SUBJECT: APPROVAL OF RESOLUTION NO. 14-1767, ADOPTING AN ADDENDUM TO THE ADOPTED AGOURA ROAD WIDENING AND CANWOOD STREET IMPROVEMENTS PROJECT INITIAL STUDY/MITIGATED NEGATIVE DECLARATION (IS/MND) AND MAKING THE REQUIRED ENVIRONMENTAL FINDINGS, PURSUANT TO CALIFORNIA ENVIRONMENTAL QUALITY ACT (CEQA), FOR THE AGOURA ROAD WIDENING PROJECT

RESOLUTION NO. 14-1767

*Agoura Road Widening Project Design
Modifications*

**Agoura Road Widening Project Design
Modifications**

Figure 2
Project Layout

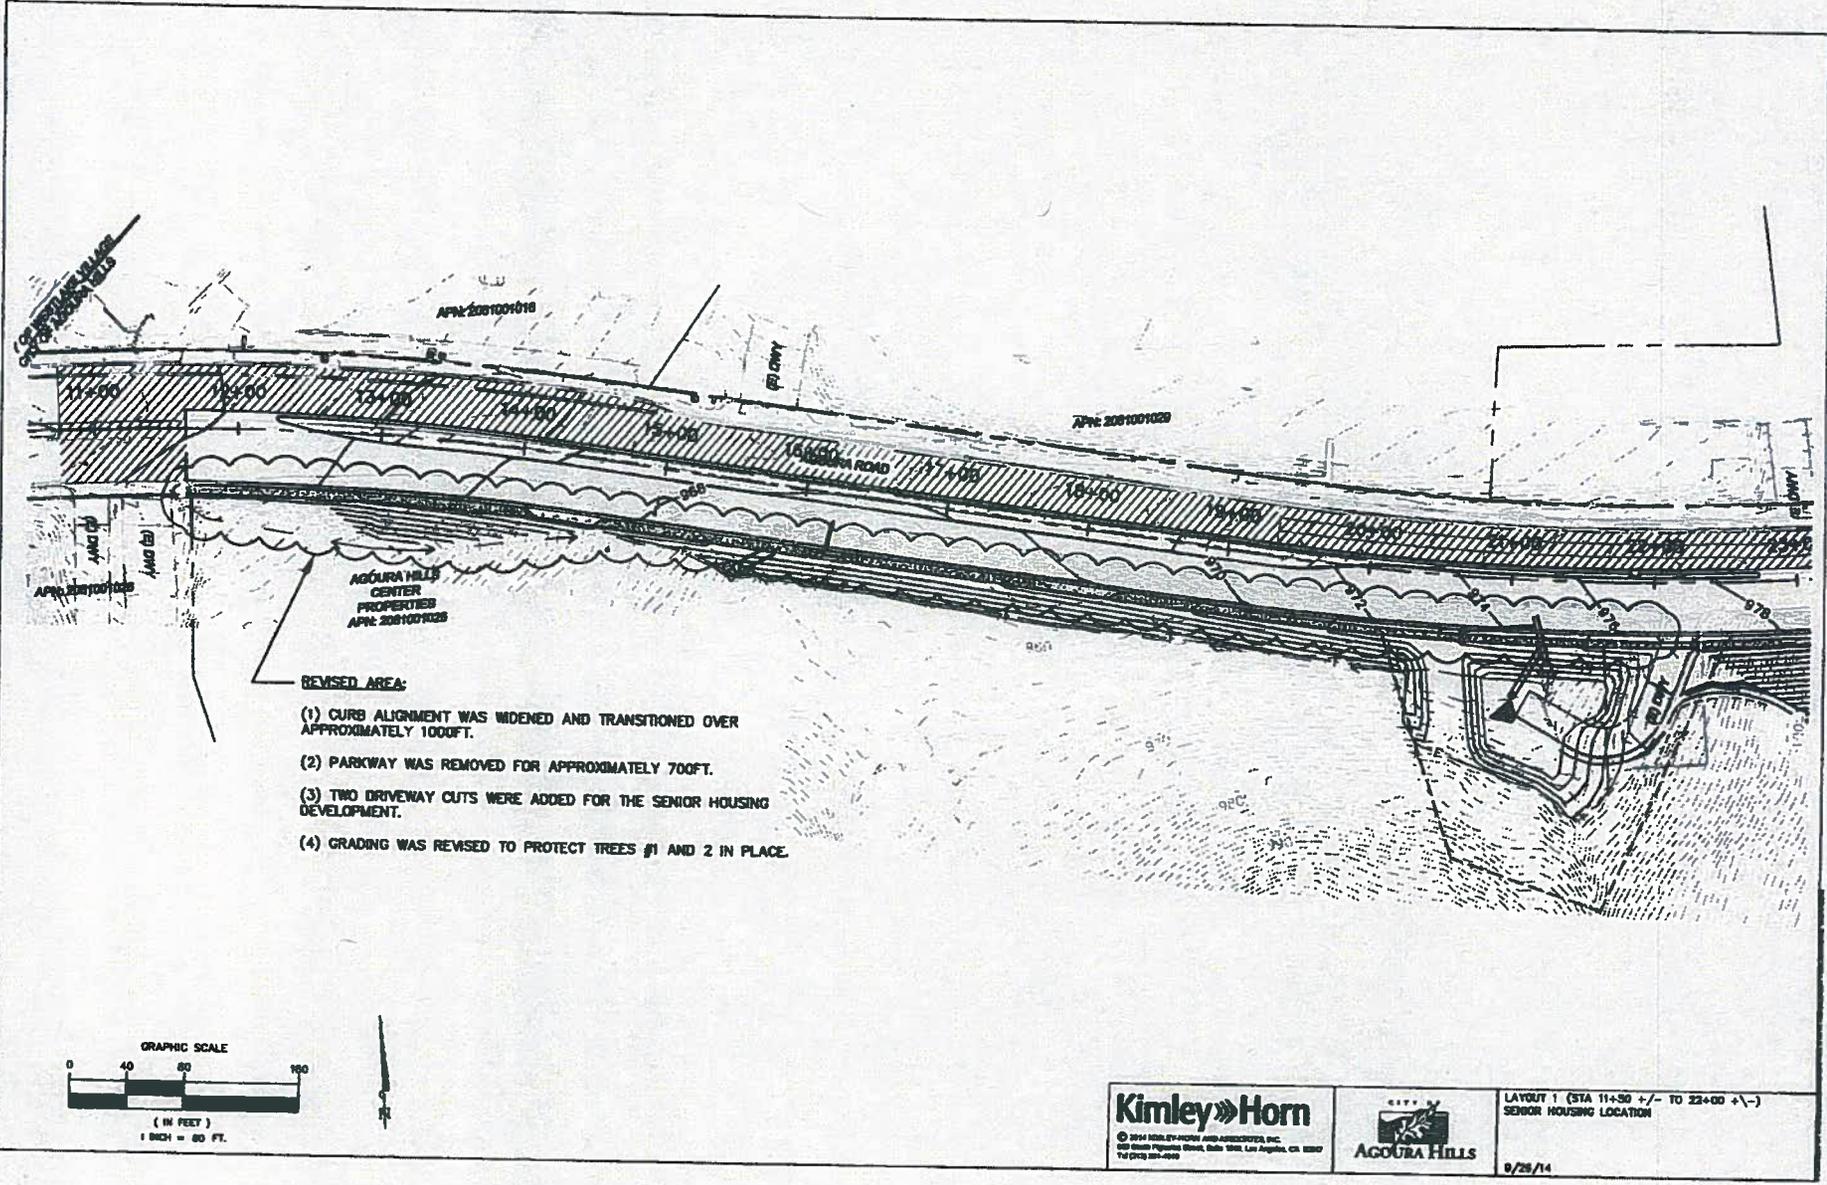
The purpose of the Agoura Road Widening Project design modifications (the “Project”) (Figure 2) is primarily to further reduce potential impacts to oak trees and noise, and to reduce the amount of hillside grading. The original Agoura Road Widening Project design attempted to minimize environmental impacts, including those to oak trees, to the extent feasible. Nonetheless, in Section IV. BIOLOGICAL RESOURCES, the IS/MND determined that 82 coast live oaks, 66 valley oaks, and 44,406 square feet of scrub oak would be removed, and the protected zone would be encroached upon for 17 other oaks. Mitigation was incorporated into the IS/MND to reduce these impacts to a level of less than significant. After adoption of the IS/MND, the City decided to consider additional design options to further decrease impacts to oak trees and scrub oak. The Project would reduce the total impact numbers to 59 coast live oaks, 60 valley oaks, and 13,462 square feet of scrub oak.

LAYOUT 1 (STA 11+50 +/- TO 22+00 +/-)
SENIOR HOUSING LOCATION

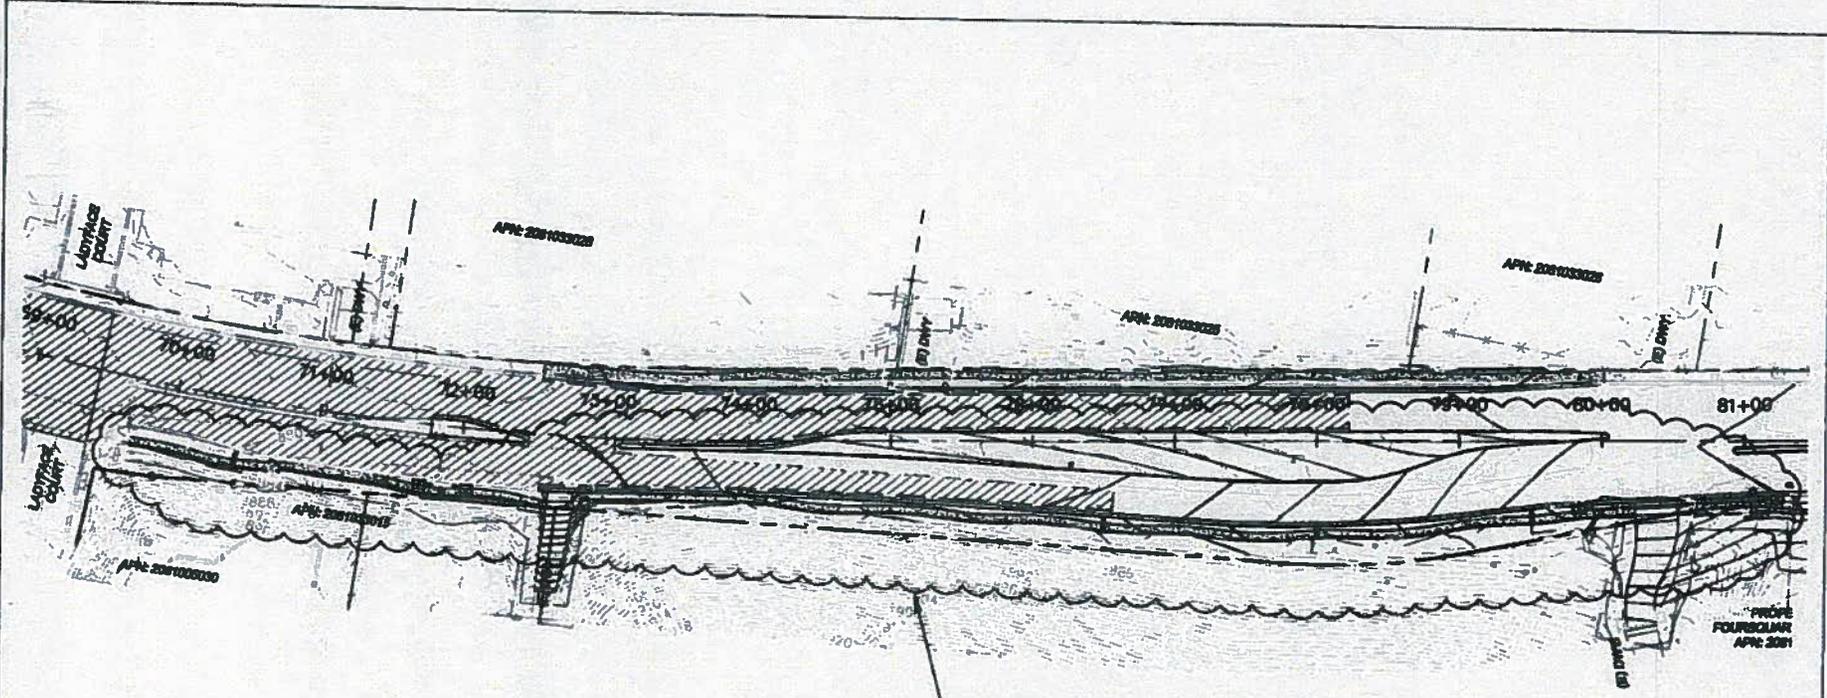
Several other modifications are proposed in select areas to minimize the project disturbance area and thereby preserve more oaks, as shown on Figure 3, Layouts 1-5. The following are the main changes. One area of landscaped median (about 200 feet long) has been reduced in width from 45 feet to 35 feet. A total of 890 linear feet of landscaped parkways has been eliminated, while another parkway area has been lengthened by 400 linear feet, although reduced in width from a range of four to nine (4-9) feet to a width of four (4) feet. Street curb alignments have been shifted and/or retaining curbs of six (6) to eight (8) inches high added. Grading has been reduced in specific areas. Road alignment has shifted by ten (10) feet in one location. Four (4) proposed parking spaces in the Agoura Village Specific Plan area of Agoura Road have been eliminated from the original design. Sidewalks have been redesigned from meandering to straight, while some have been reduced in width (in Agoura Village). All sidewalks would be a minimum four (4) feet in width, consistent with the Americans with Disabilities (ADA) Act.

REVISED AREA:

LAYOUT 2 (STA 72+50 +/- TO 80+50 +/-)
 EAST OF LADYFACE COURT

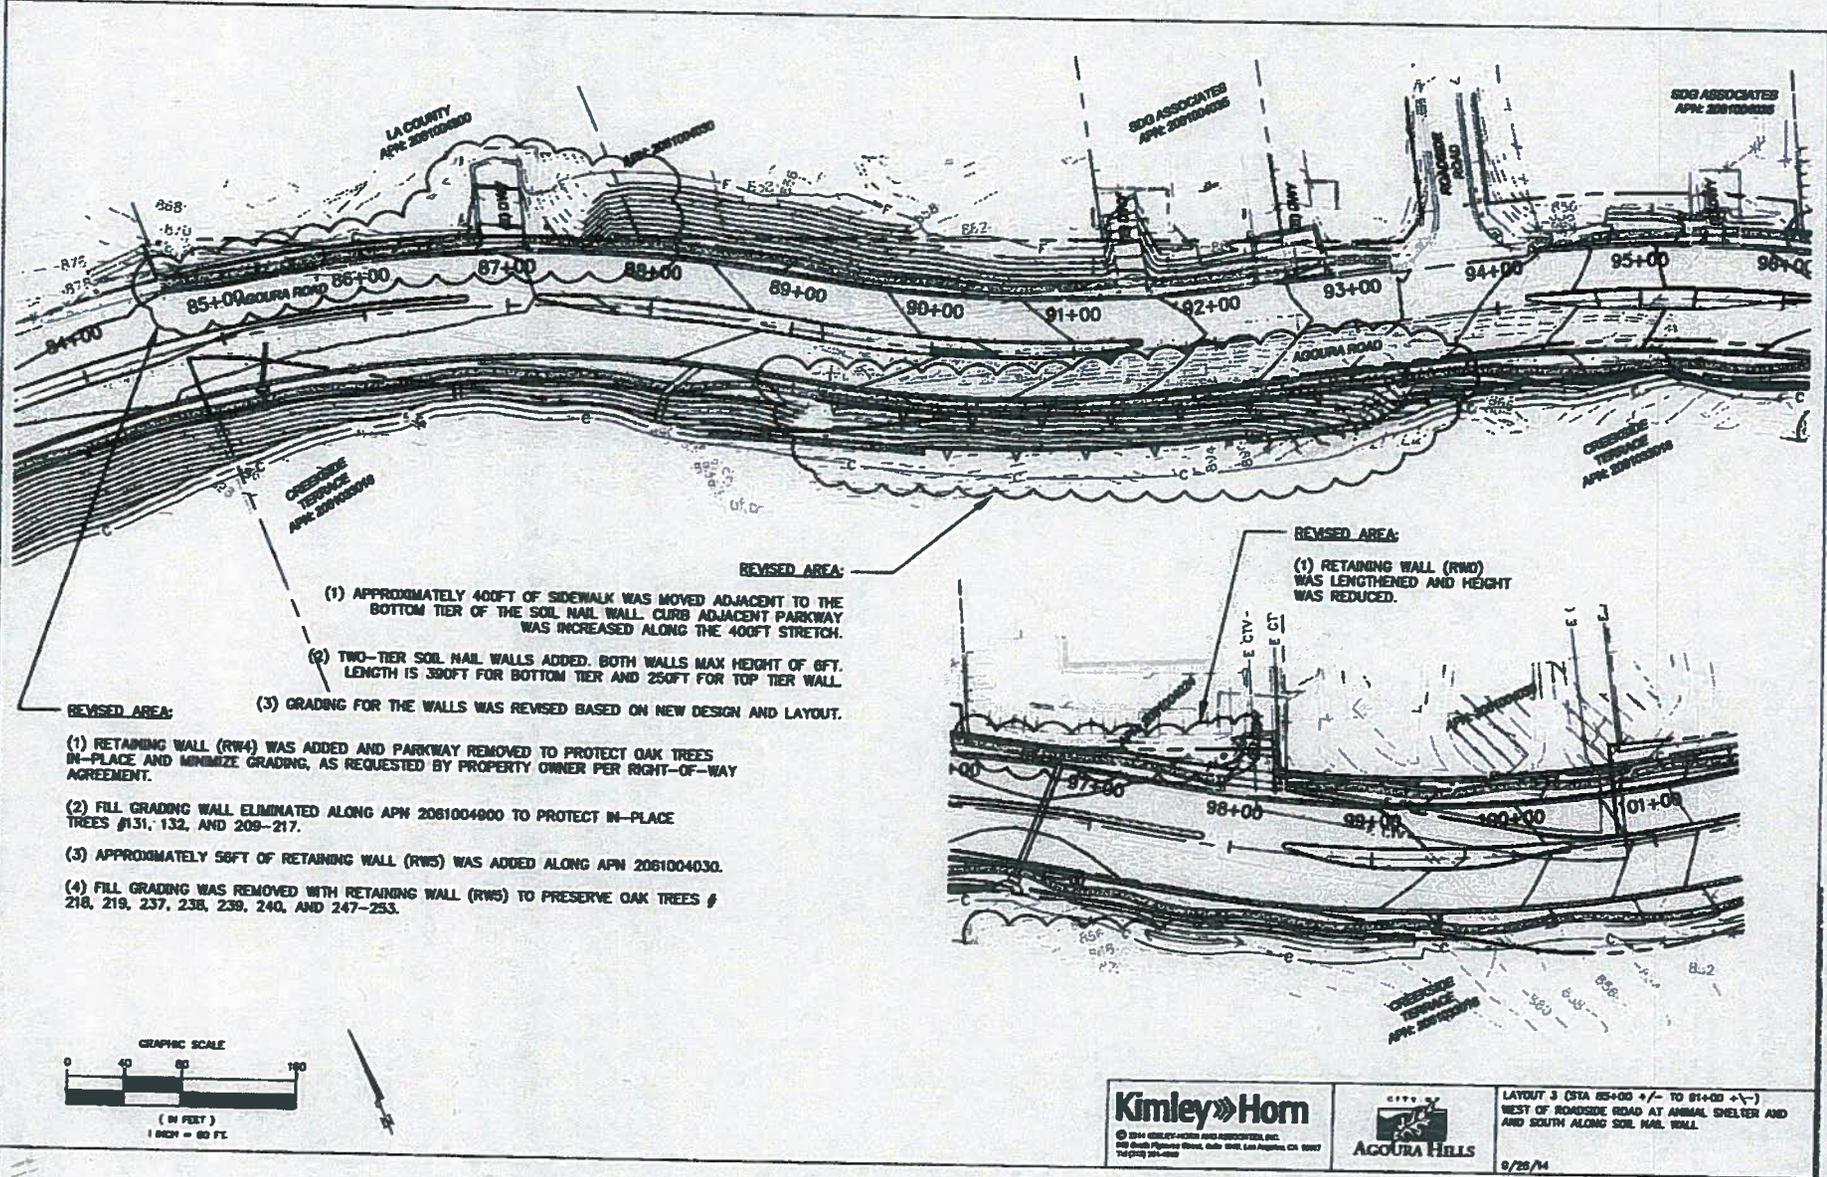
REVISED AREA:

LAYOUT 3 (STA 85+00 +/- TO 91+00 +/-)
 WEST OF ROADSIDE ROAD AT ANIMAL SHELTER AND
 AND SOUTH ALONG SOIL NAIL WALL.

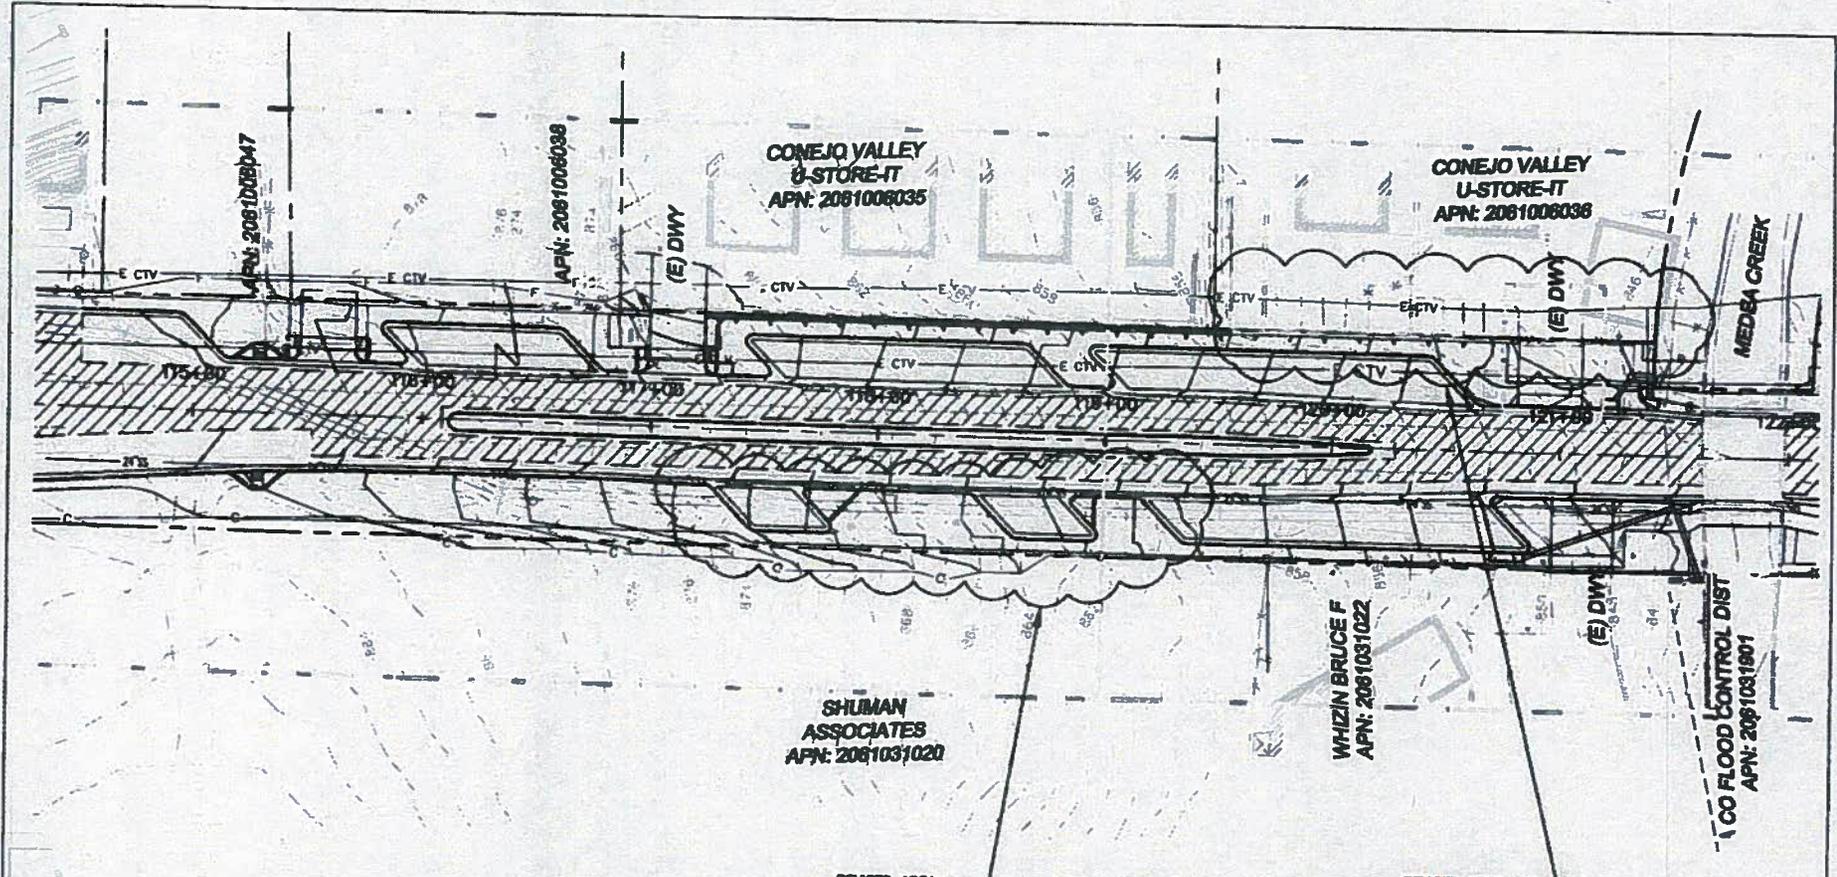
REVISED AREA:

REVISED AREA:
